PRODUCT CHANGE NOTIFICATION (PCN)

AMJE0909-0050-BUB-24
MODULAR CABLE

CHANGE NOTIFICATION: PCN 20220509_AMJE0909-0050-BUB-24

DESCRIPTION OF CHANGES:
CHANGE OF DATA SHEET
CHANGE OF DATA SHEET
New Draw.-No. ASS_7945_CArev02

AMJE0909-0050-BUB-24 OLD VERSION

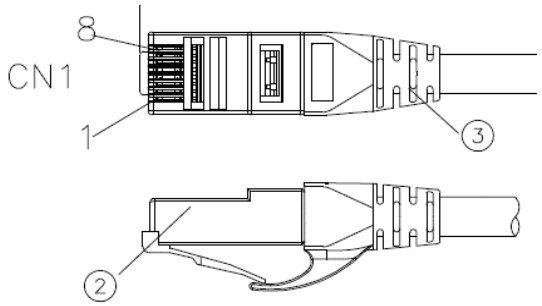
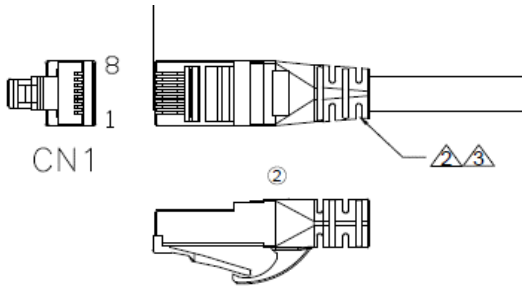
③	Molding	PVC 45P Color: see order code	NA	KG
②	CONNECTOR	RJ45 8P8C two fork Short type 3u" gold plated	2	PCS
①	CABLE	CAT6 UTP (24AWG*1PR)*4+PVC OD=5.8±0.3MM Color: see order code	NA	MM
NO:	NAME	DESCRIPTION	Q'TY	UNIT

3	Molding	PVC 65P Color: see order code ②	NA	KG
2	CONNECTOR	RJ45 8P8C PLUG 3u" gold plated ②	2	PCS
1	CABLE	CAT6 U/UTP (24AWG*1PR)*4+Cross+PVC Jacket OD=5.8± 0.3MM Color: see order code ②	NA	MM
NO:	NAME	DESCRIPTION	Q'TY	UNIT

Drawing-No.
ASS 7945 CA

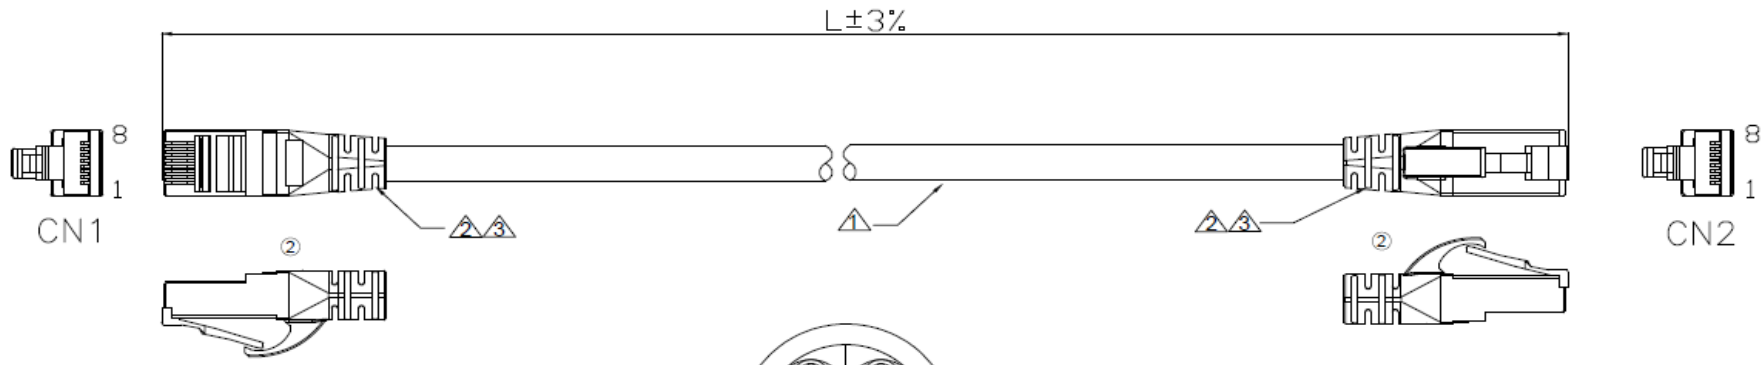
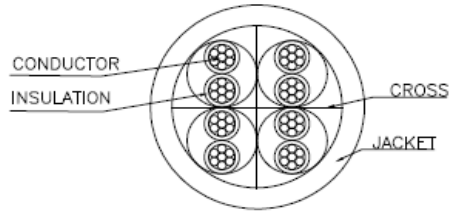
Id.	Modification	Date	Name
②	Change the plant	09.05.2022	Luca
①	Update the WSW order code	02.06.2017	Amy
⓪	Drawn	30.03.2017	Amy

NO:	NAME	DESCRIPTION	Q'TY	UNIT
3	Molding	PVC 65P Color: see order code ②	NA	KG
2	CONNECTOR	RJ45 8P8C PLUG 3u" gold plated ②	2	PCS
1	CABLE	CAT6 U/UTP (24AWG*1PR)*4+Cross+PVC Jacket OD=5.8± 0.3MM Color: see order code ②	NA	MM
